February 8, 2001

Subject: Peach Bottom Atomic Power Station, Units 2 and 3
License Change Application ECR No. 99-00015

License Change Application ECR No. 99-00015

Figure 3.4.1-1 (page 1 of 1)
THERMAL POWER VERSUS CORE FLOW
STABILITY REGIONS

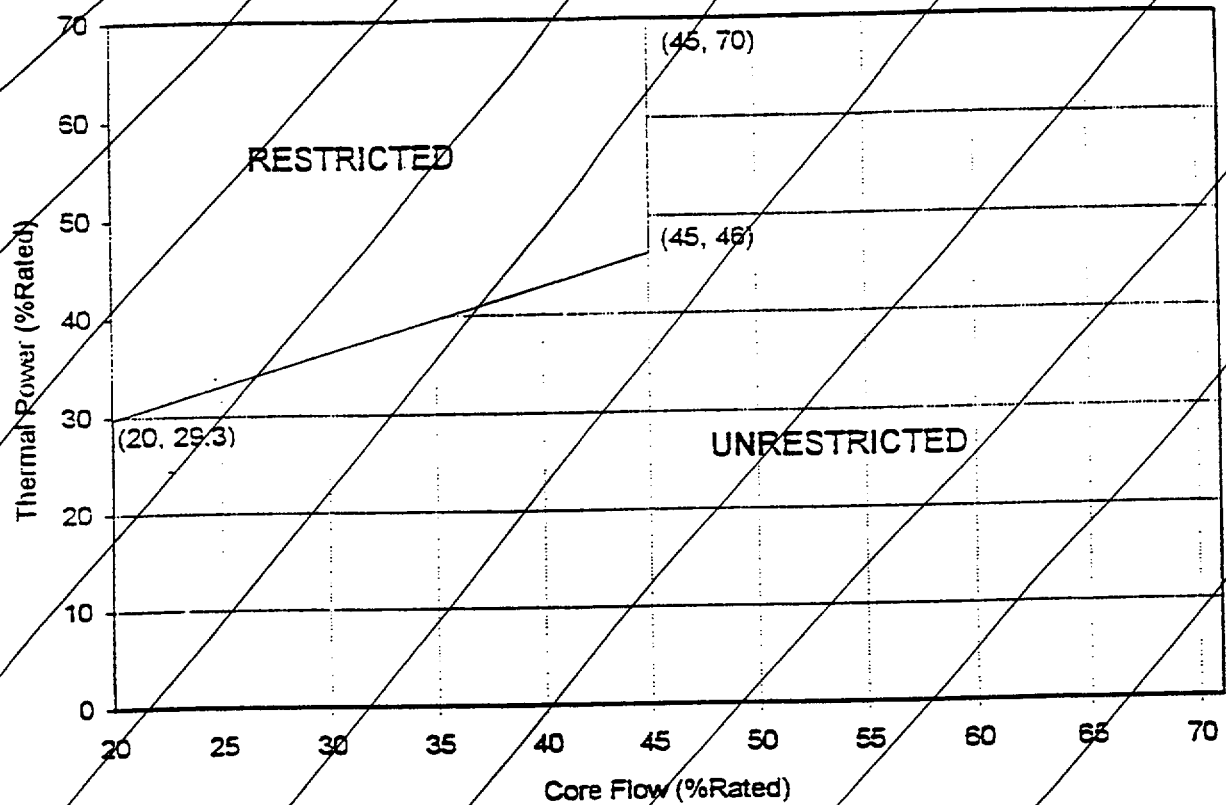
LCO restrictions on operating region (references to Figure 3.4.1-1) will be deleted from the LCO both for two loop and single loop operating conditions. Conditions A, B and C

and their associated Required Actions, and Required Action F.1, each associated with operation in the Restricted Region and included previously as part of the ICA actions, will be deleted. These changes, along with deletion of the related Bases discussions, effectively delete the Technical Specification requirements for the ICAs. [Note: The NUMAC PRNM LTR do not address deletion of ICA related Technical Specifications. Therefore, all Specification 3.4.1 changes are beyond those covered by the NUMAC PRNM LTR NEDC-32410P-A.]

Two recirculation loops with matched flows shall be in operation ~~with core flow as a function of THERMAL POWER in the "Unrestricted" Region of Figure 3.4.1-1.~~

One recirculation loop shall be in operation with ~~core flow as a function of THERMAL POWER in the "Unrestricted" Region of Figure 3.4.1-1~~ and with the following limits applied when the associated LCO is applicable:
